Subject: License Amendment Request for Hematite  
Organizational Changes

**ENCLOSURE I**  
**COMBUSTION ENGINEERING, INC.**  
**HEMATITE NUCLEAR FUEL MANUFACTURING FACILITY**  
**REQUEST FOR LICENSE AMENDMENT**  
**LIST OF AFFECTED PAGES**

**HEMATITE NUCLEAR FUEL MANUFACTURING FACILITY  
REQUEST FOR LICENSE AMENDMENT**

Combustion Engineering requests that License No. SNM-33 for its Hematite Nuclear Fuel Manufacturing Facility be amended to update the organization chart and personnel resumes, to add descriptions for key positions important to safety and for subordinate supervisory positions and to add the functions of a Hematite Safety Committee. License pages affected by this amendment request and their respective revision numbers are listed below. The change pages are contained in Enclosure II.

**FIGURE II.3-1  
HEMATITE ORGANIZATION CHART  
KEY POSITIONS IMPORTANT TO SAFETY AND LINE OF AUTHORITY**

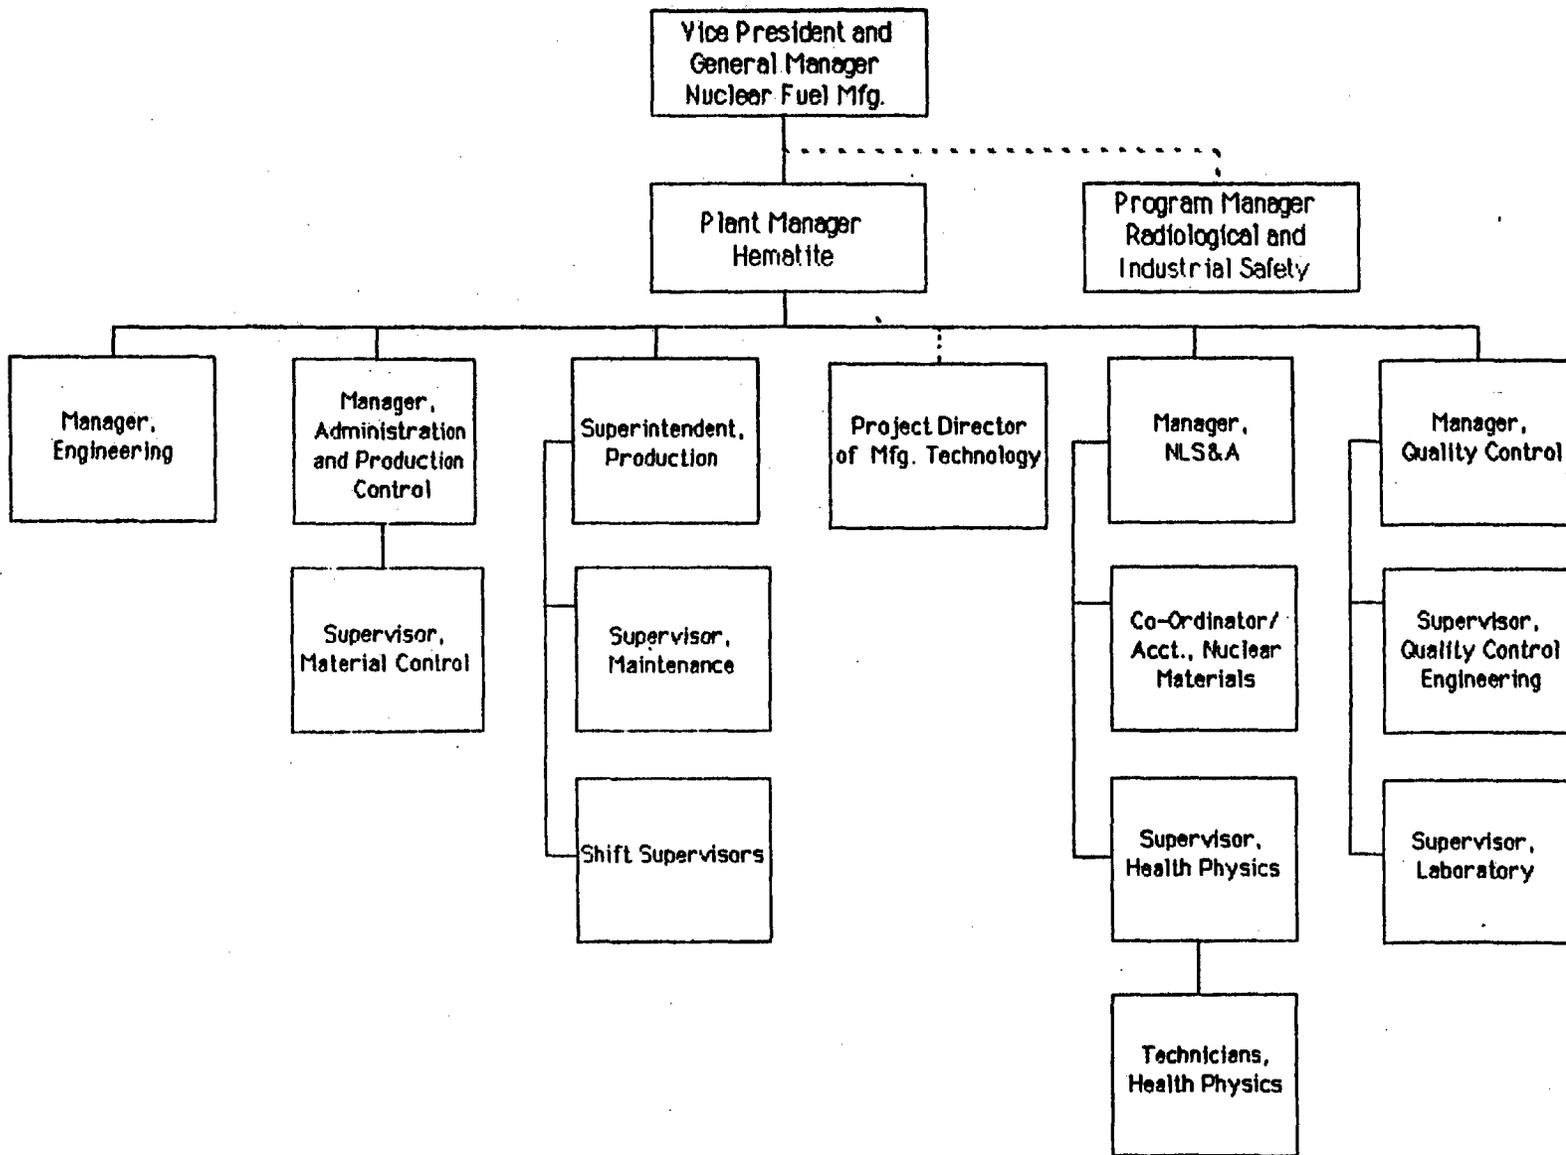
Figure II.3-1 is the organization chart for the key positions and for the line of authority to top management. Figure II.3-2 is the complete Hematite plant organization chart. The following sections describe the supervisory and higher level positions shown in Figure II.3-1 that are not included in Section I.2.1.
